工程指示 / 要求簡箋(E.I.)

工程指示編號：EI / 4488 / 22 修改版次：-
 工程編號：J - 858 工程名稱：將軍澳日出康城 11
 工程項目：佛沙窗 留意安裝事項 PF 12.22
 收件人：生統 發件人：Ant Yeung 日期：22/03/2022

PROJECT: PROPOSED RESIDENTIAL DEVELOPMENT AT TROT, TSEUNG KWAN O, N.T.

TITLE: TYPICAL DETAIL FOR PRECAST ALUM. WINDOW

DWG NO.: J858-PW-6001 REV.: C

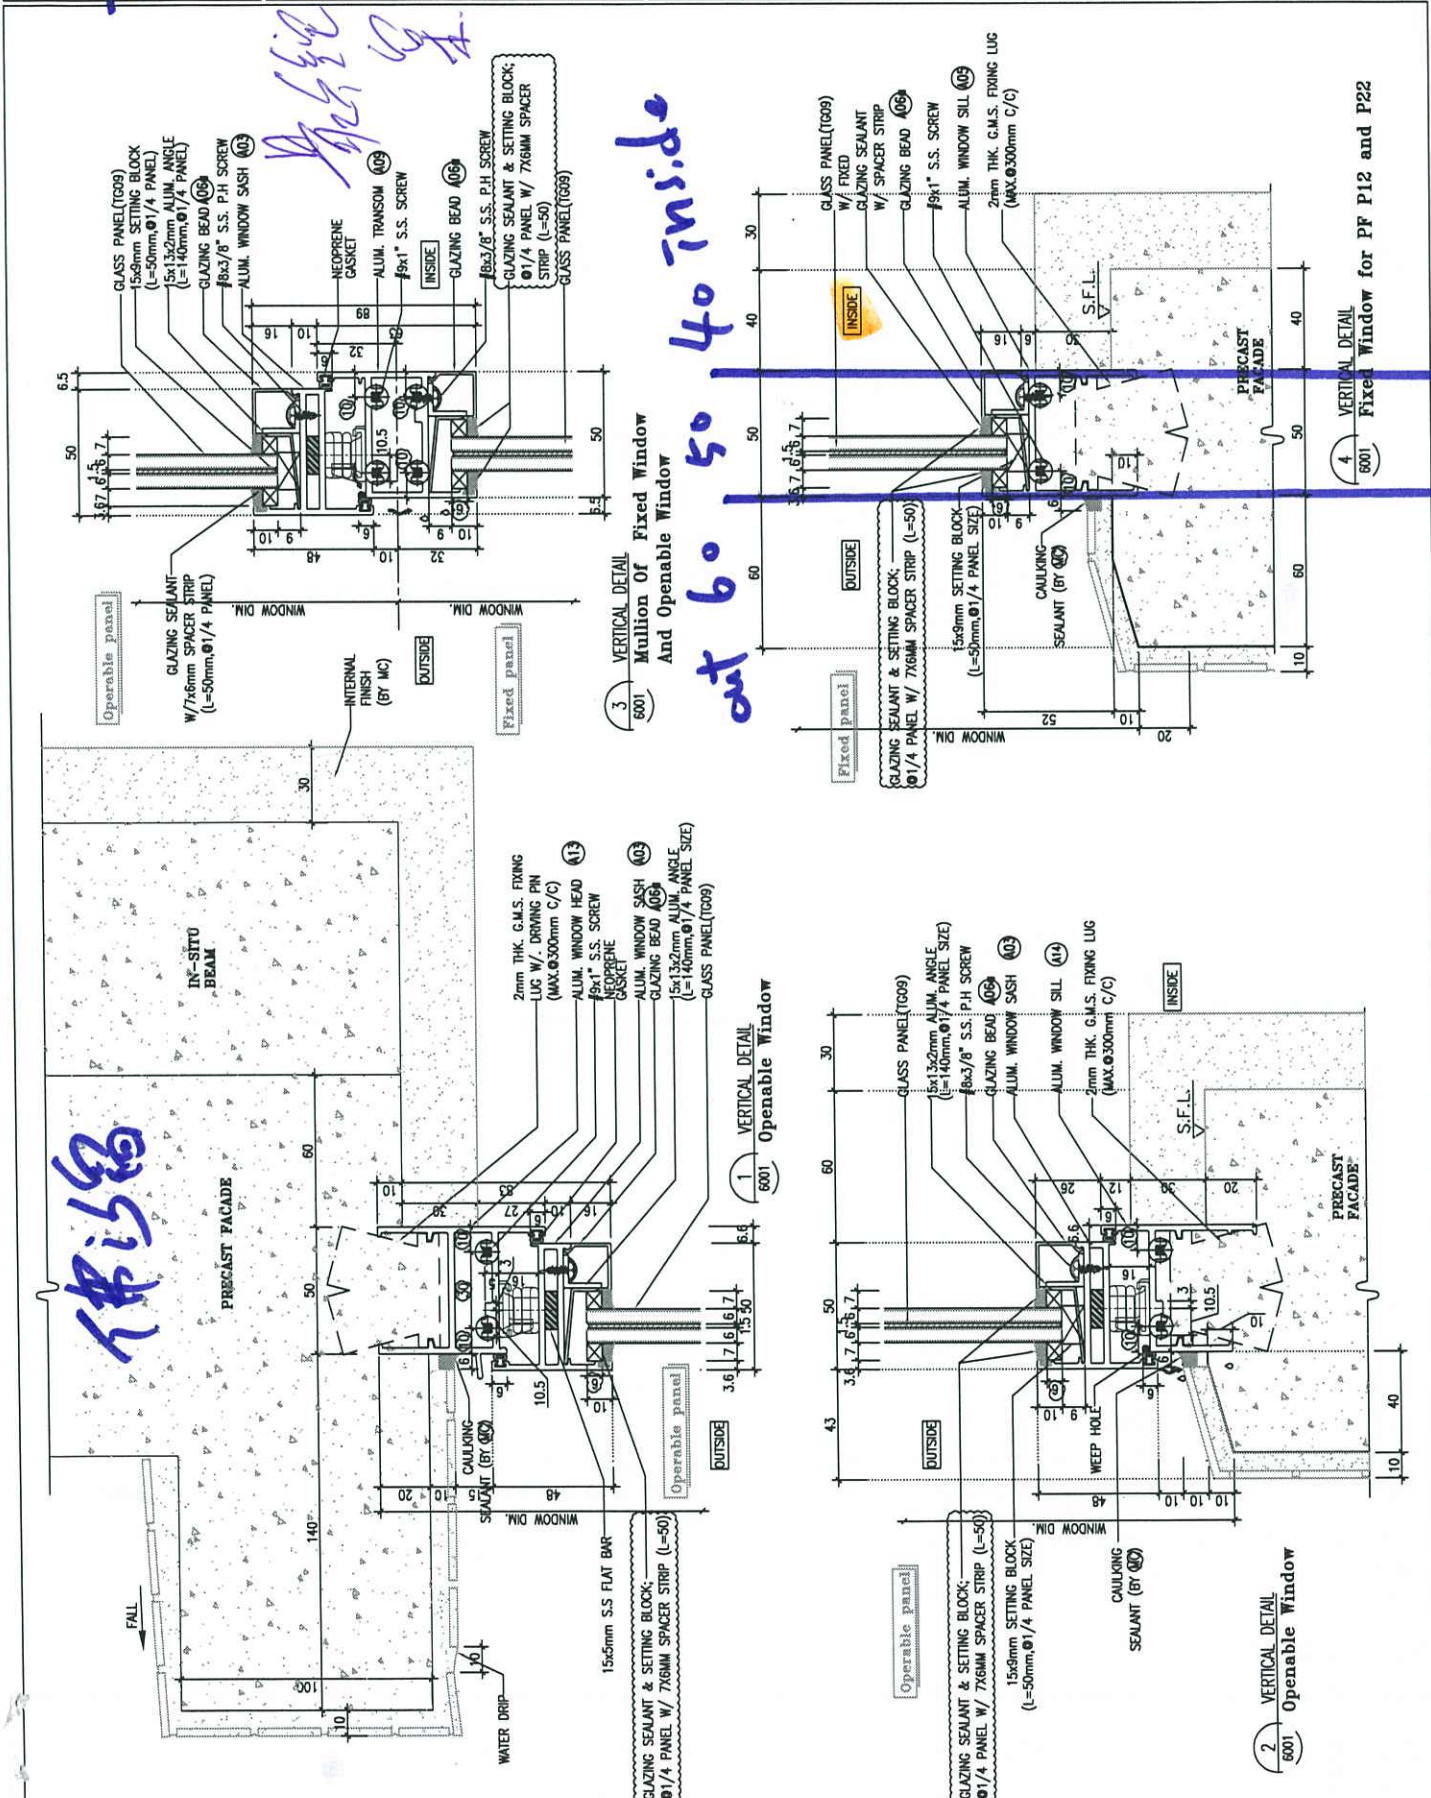
因應則師要求。此 4 款窗的安裝為 40 室內/ 50 窗/ 60 室外，(這樣不需加欄河玻璃)

We confirmed the proposed detail of precast window which was discussed at site tower coordination meeting in December, 2021, to avoid internal finishes >75mm that is below 500mm A.F.F.L.. Please revise accordingly and advice if there is any adverse implication. Thank you.

Dear Jun , Brian , Ka hei
早前已在2022.01.27 RFI 會議確認 (PW 2103) (PF12,PF22) 40mm inside / 50mm win/ 60mm outside
的 setting out ,
以不需再額外加上欄河玻璃。請留意。
請協調佛沙廠的生產,
謝謝
